# SPARTAN CHASSIS, INC.

**CSB06-250-002**

## CAMPAIGN SERVICE BULLETIN

**SUBJECT:** Front Suspension- IFS84

**FIG.5-1**

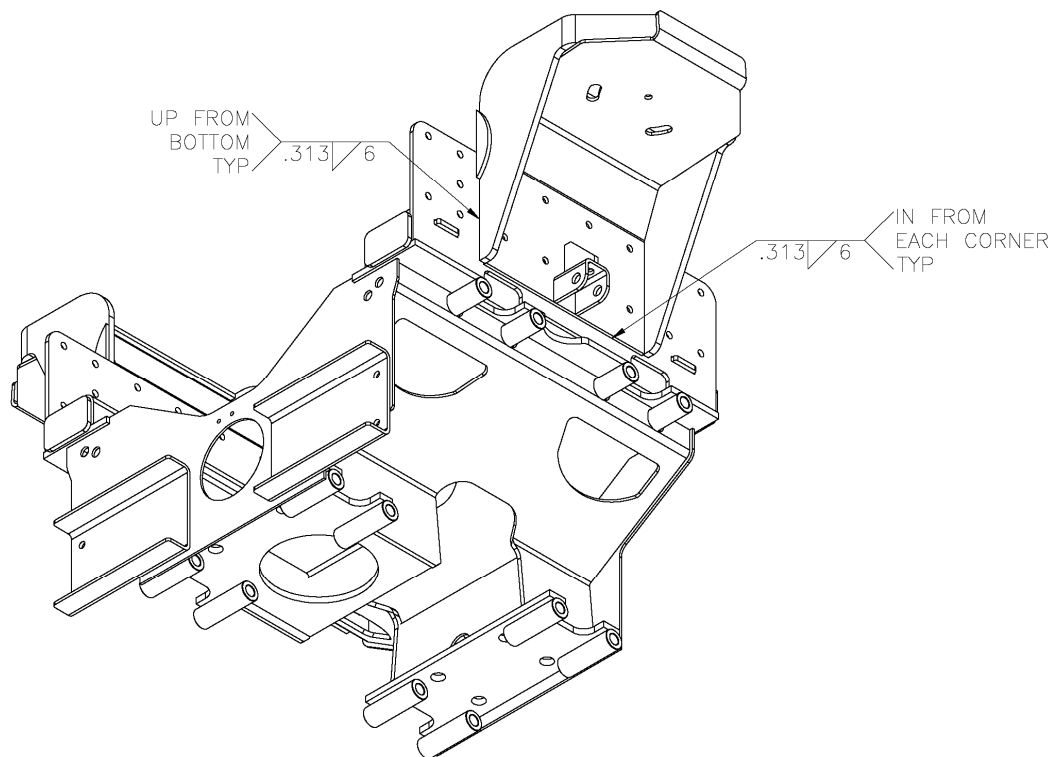
**CONDITION:** Upward forces generated by the air spring may cause the lower end of the upper spring tower to pull away from the main cradle's mounting plate. This creates the potential for upper spring tower mounting fastener failure and the possible subsequent failure of the upper spring tower's ability to maintain control over the upper spring position.

**CORRECTION:** Inspect condition of the upper spring towers; replace if necessary. Weld upper spring towers to the main cradle.

- 6C. **Refer to FIG. 5-1. Weld the upper spring tower to the main cradle mounting plate as shown in the attached diagram. All welding should be done using a 7018 low hydrogen electrode or equal. Apply a minimum of 300 amps, reverse polarity. All surfaces in the area of the weld should be cleaned of dirt, grease, paint, etc. (using a wire brush, side wheel grinder, or similar method) before welding. Approximately 2 feet of weld will be required per upper spring tower.**
